Change order

| AMENDMENT OF SOLICITATION/MODIFICATION OF CONTRACT   |  |  |  | 1. CONTRACT ID CODE  | PAGE 1 OF 3 PAGES |
|--|--|--|--|--|-------------------|
| 2. AMENDMENT/MODIFICATION NO.<br>Contract Modification No. 011   |  | 3. EFFECTIVE DATE<br>see Block 16C   |  | 4. REQUISITION/PURCHASE REQ. NO.   |                   |
| 5. PROJECT NO. (If applicable)<br>North Bend Road<br>OR PFH 97-1(8)  |  | 6. ISSUED BY<br>CODE<br>Western Federal Lands Highway Division<br>610 East Fifth Street<br>Vancouver, WA 98661 |  | 7. ADMINISTERED BY (If other than Item 6)<br>CODE  |                   |

| CONTRACT MODIFICATION                             |   |                   |

### VEE DITCH

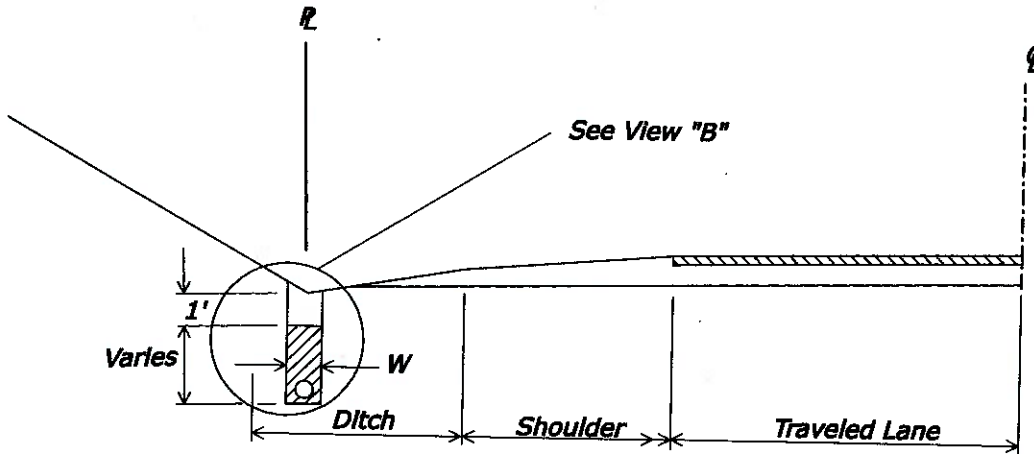
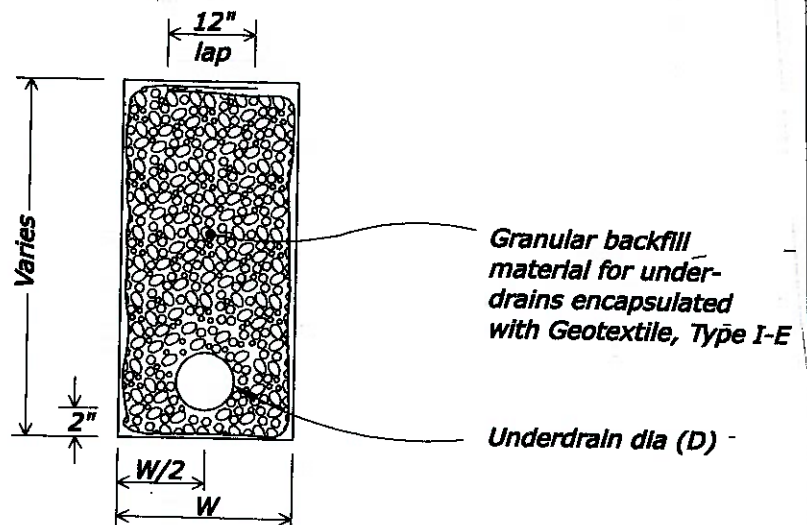
The contractor is directed to procure and install an underrain system between Sta. 126+50 Lt. to 131+50 Lt., approximately. Exact locations will be determined by the Contraction Officer. Work and material shall conform to Section 605 of the FP-03. See page 3 of 3 for a typical section.

The contractor will modify the culvert inlet at Sta. 128+25 Lt. as per direction of the Contracting Officer.

1. Location of pipe underdrains may be adjusted by the CO.
2. Minimum underdrain grade is 0.5 percent.
